Re: Final Plat S/D 87-48 - P.S. ADDITION

Final Plat
SUBDIVISION REPORT

S/D No.: 87-48 Name: P.S. ADDITION

FINAL PLAT P. S.

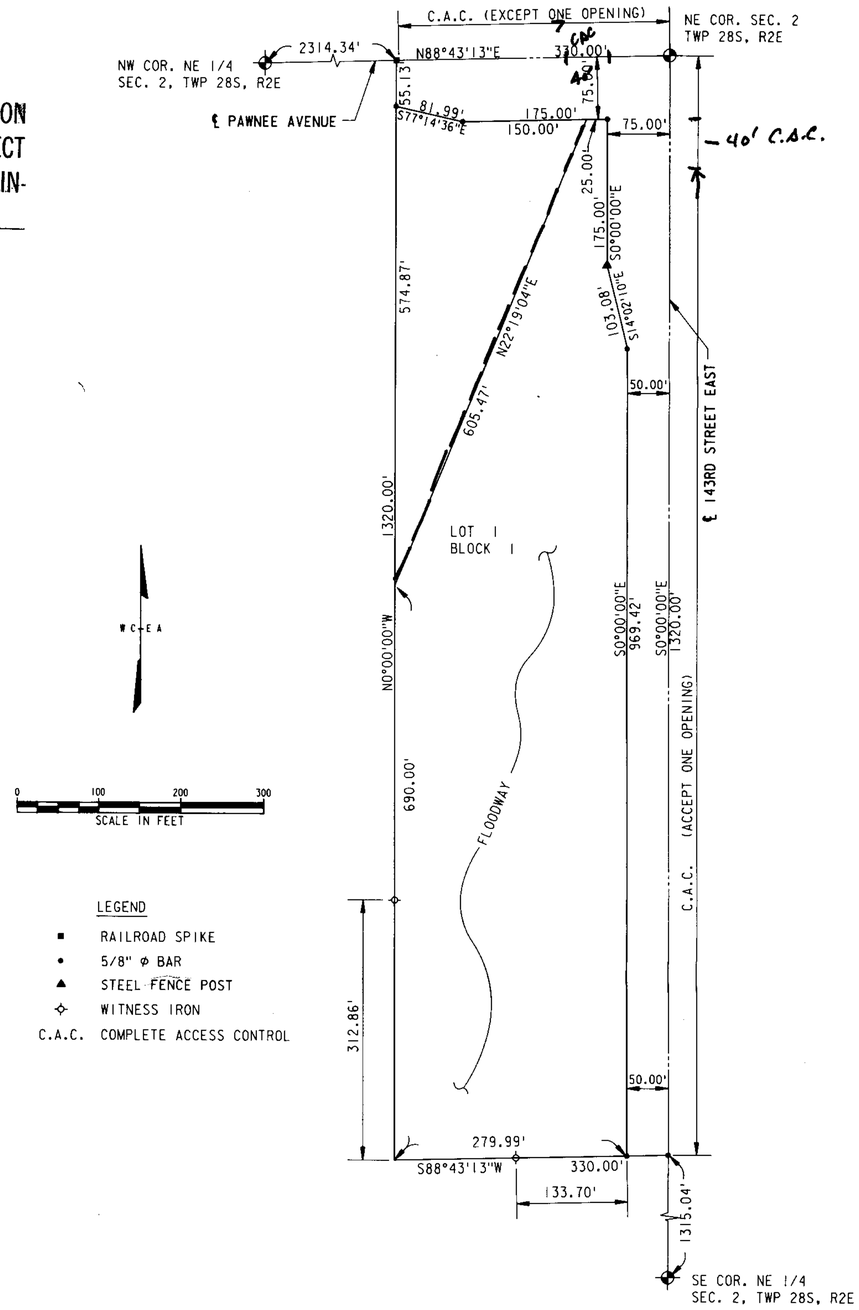
D. On the final plat tracing, a 25-foot building setback shall be indicated from Pawnee Avenue.

F. On the final plat tracing, the spelling of the Deputy City Clerk's name shall be corrected to Rea.

G. Since the floodway is to be platted as a part of the lot, as opposed to creating a separate reserve for floodway purposes, the line denoting the northwesterly limit of the floodway shall be changed to a dashed line. This change will clearly indicate that the floodway is a part of the subject lot.

H. On the final plat tracing, "complete access control" shall be dedicated to Pawnee Avenue from the east 40 feet of the lot. "Complete access control" shall also be dedicated to 143rd Street East from the north 40 feet of the lot. These changes in access control shall be reflected on the face of the plat.

I. The applicant's engineer is advised that the Register of Deeds is requiring the name(s) of the notary public, who acknowledges the signatures on this plat, to be printed beneath the notary's signature.
